AGENDA FOR REGULAR MEETING VILLAGE OF TINLEY PARK PLAN COMMISSION

PLAN COMMISSION STAFF REPORT

Apple Chevrolet – Site Plan Review

8585 W. 159th Street

PLAN No. 10/18/2015
SHEET No. C-1

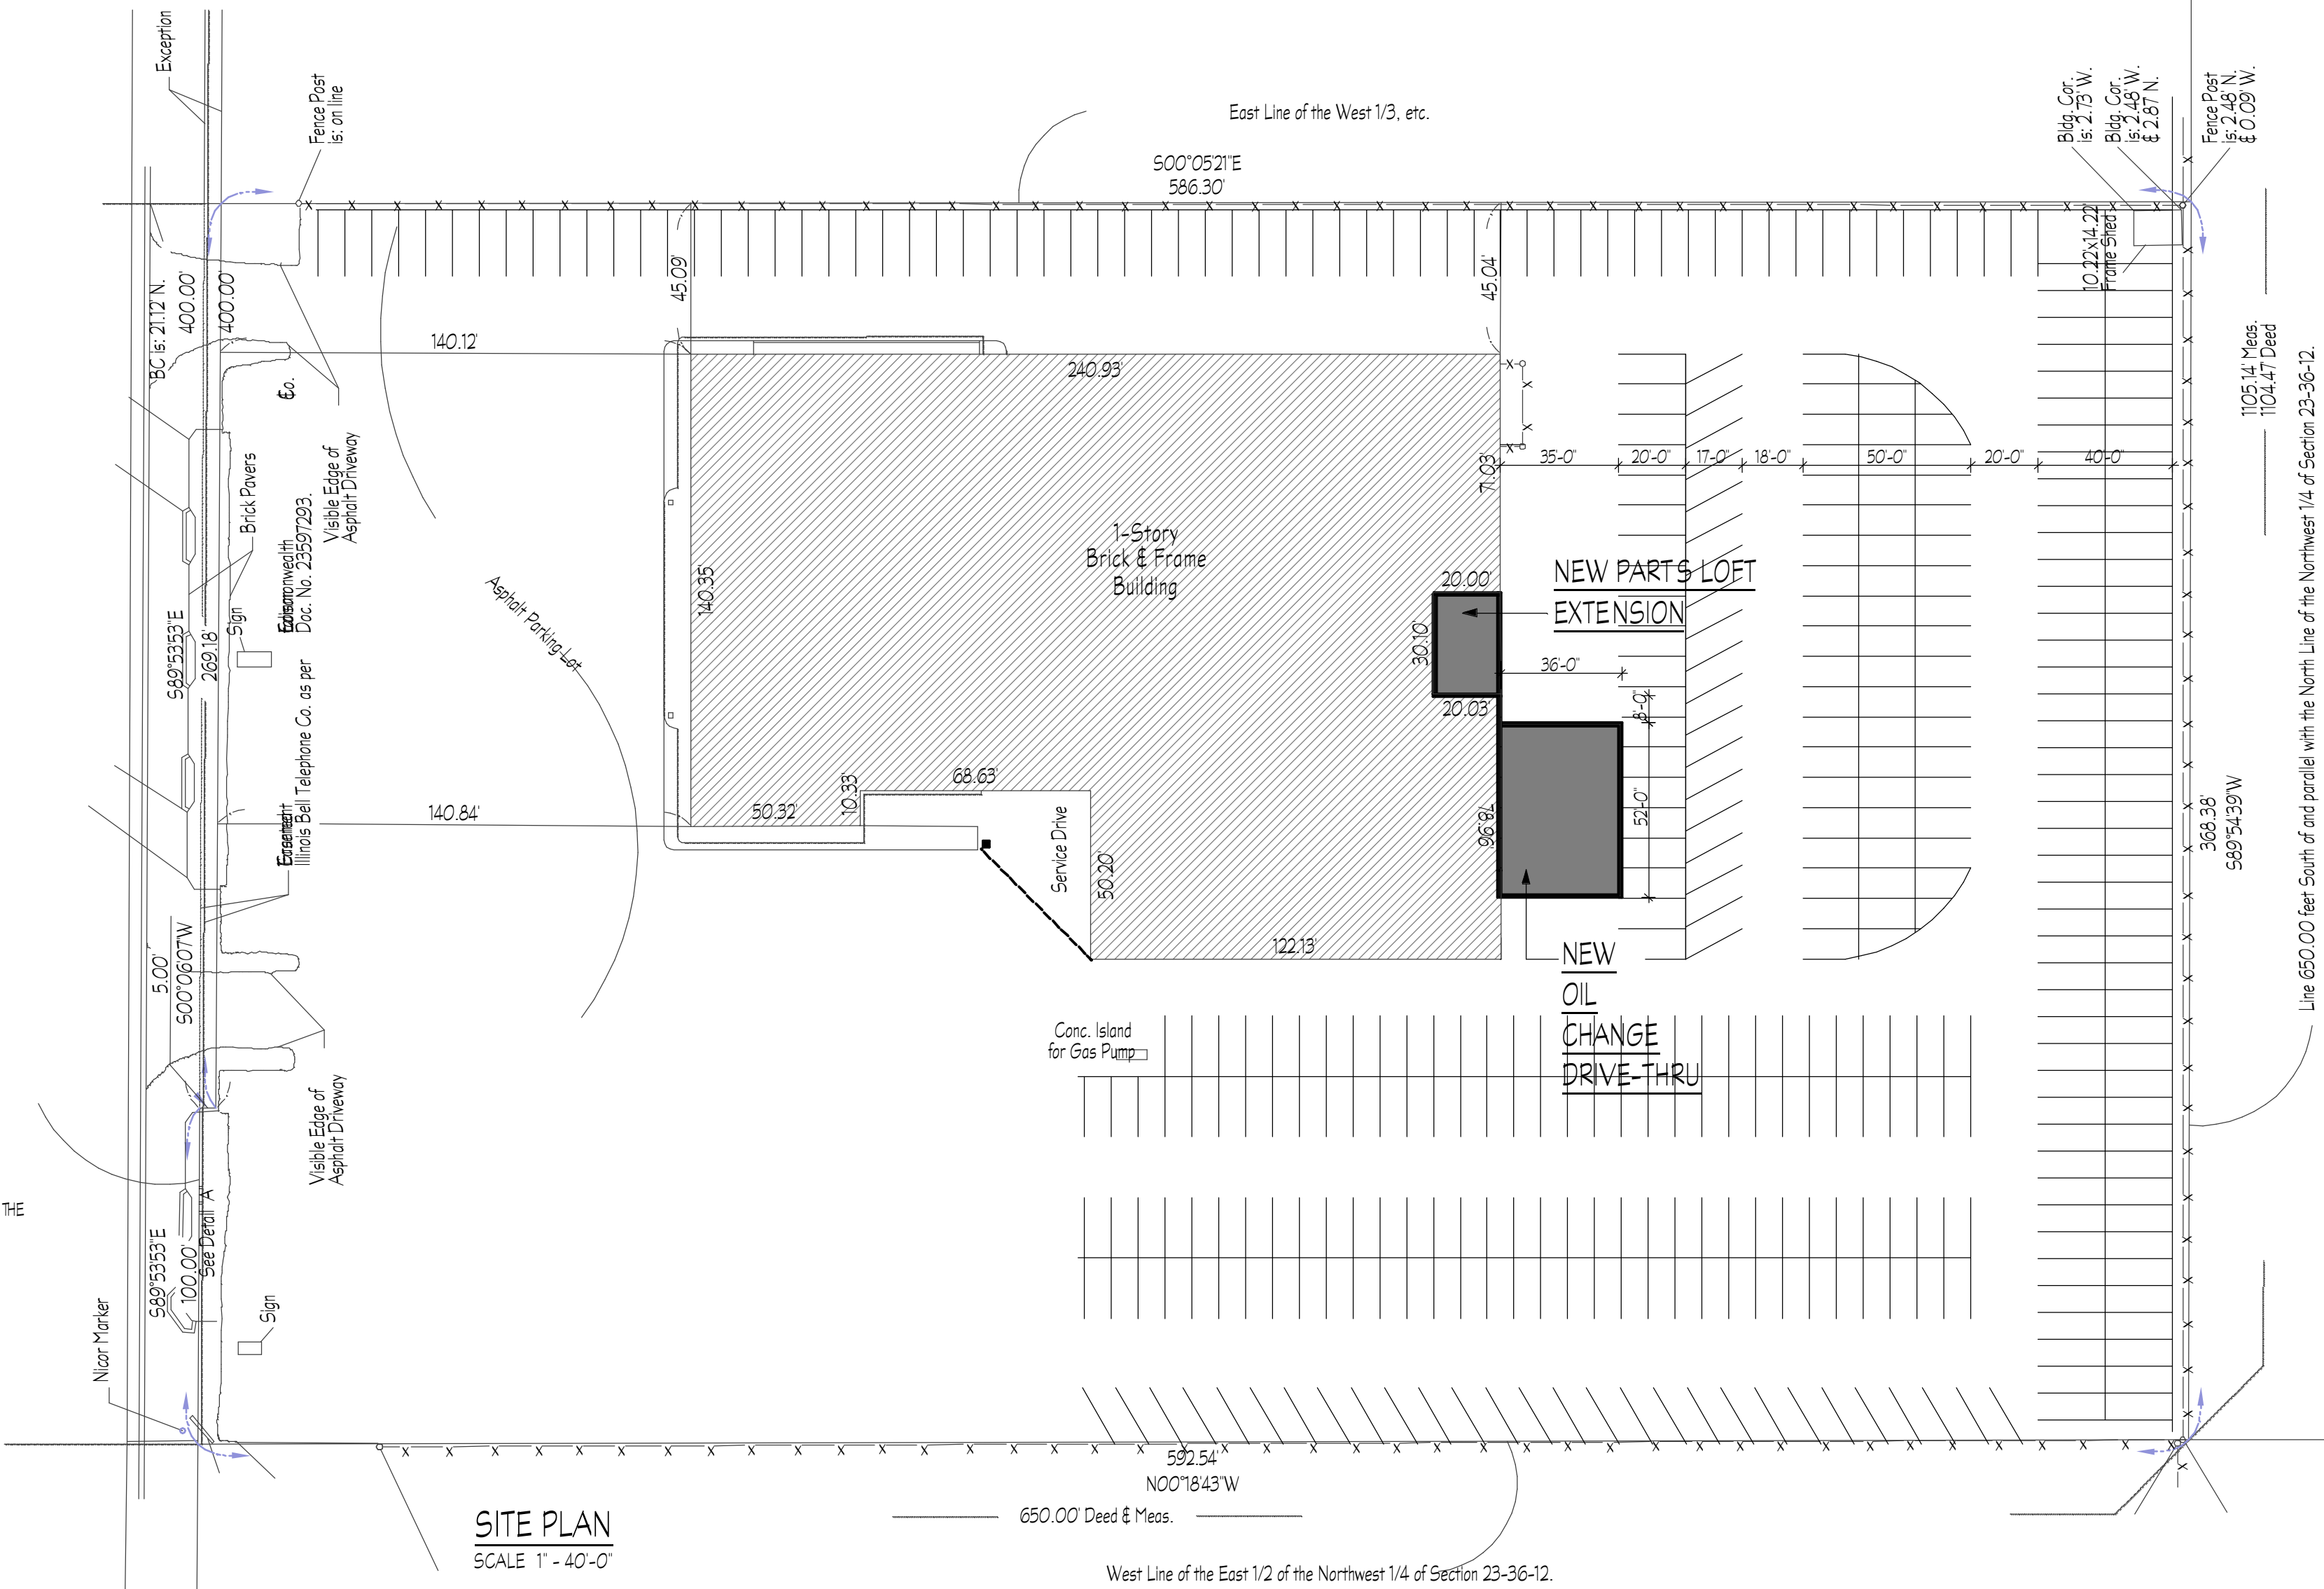
The Site Plan has been distributed to Staff (Building Department, Fire Department, Police Department, Public Works, and consultant Engineers and Landscape Architects). There were no substantive comments from most departments with the exception of the Fire Department, which expressed concern regarding the parking layout at the rear of the building. The Applicant confirmed that there were no changes to the existing configuration. The Fire Department also requested that signage be affixed above the wall hydrant on the south wall as well as a ‘No Parking’ sign be erected above the wall hydrant and bollards for vehicle impact be installed in front of the wall hydrant. The Applicant has agreed to these requests.

“...make a motion to approve the Site Plan for Apple Chevrolet, 8585 W. 159th Street, per plans prepared by N. Batistich, Architects, dated May 18, 2015, received February 24, 2016, for purposes of constructing a 1,872 square foot oil change facility and 600 square foot parts storage area at the rear of the existing building. The façade will be constructed of the same materials as the existing façade, painted the same color; circulation will remain as it currently exists; and signage and bollards as requested by the Fire Department will be provided.”
